# Dammon Engineering, Inc.

November 21, 2008

RE: P0337937  
HIGHLANDS INDUSTRIAL PARK

BAY #3

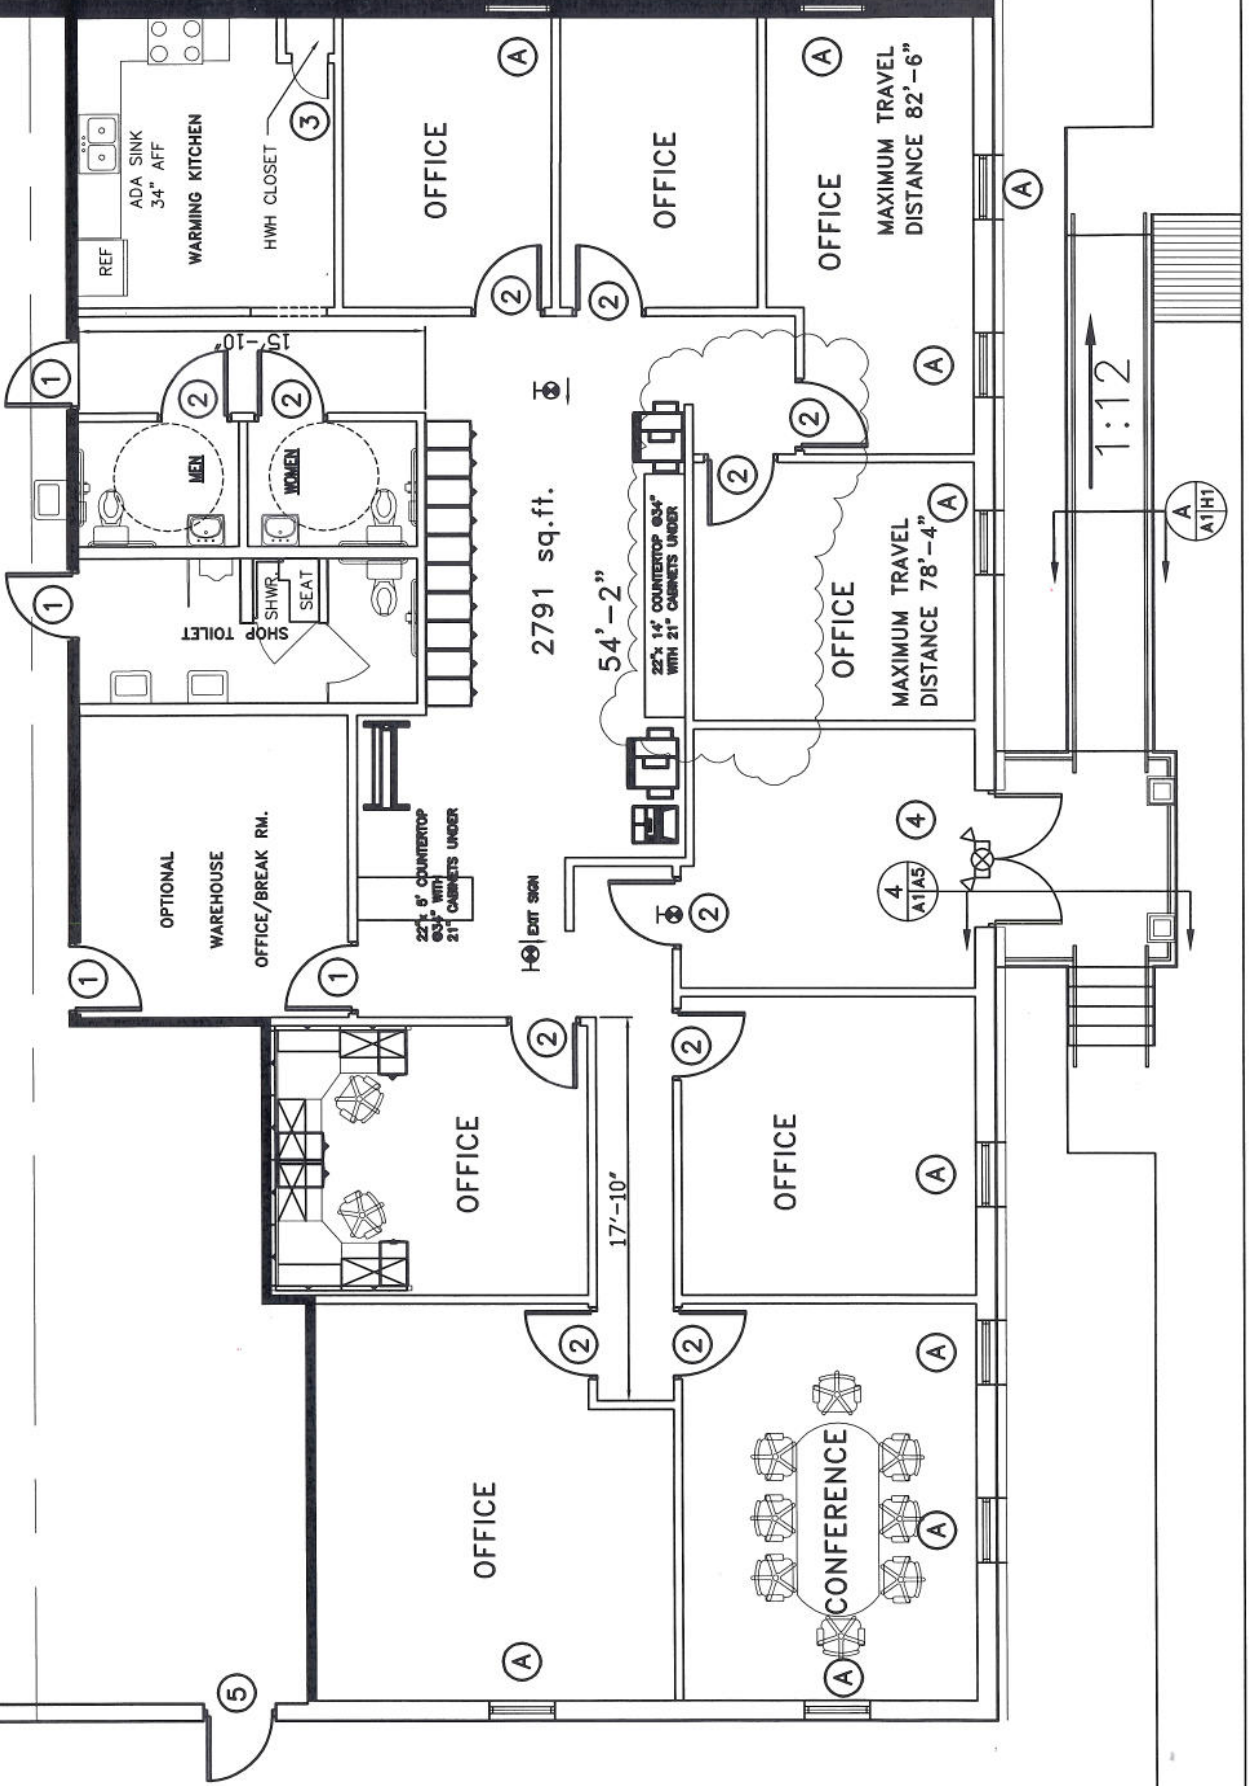
With regard to the above referenced project. Changes in the office layout have been changed. The allowed travel distance for a single exit in business is 100 ft. The change in office layout created a maximum travel distance of 82'-6" for this project.

Please see attached.

*MODIFICATION APPEARS  
TO BE ACCEPTABLE  
Otis Ramke, ~  
11/24/08*
